RECREATION & PARKS | ROSSI POOL RENOVATION PROJECT

Civic Design Review - Phase 3 Presentation
February 11, 2019

CDR PHASE 2 COMMENTS AND RESPONSES

UPDATED EAST PERSPECTIVE

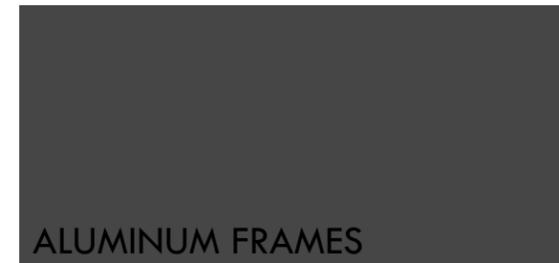
5) using preferred color scheme of cream base and bronze metal.

RESPONSE: a color scheme using cream base and bronze metal has been specified.
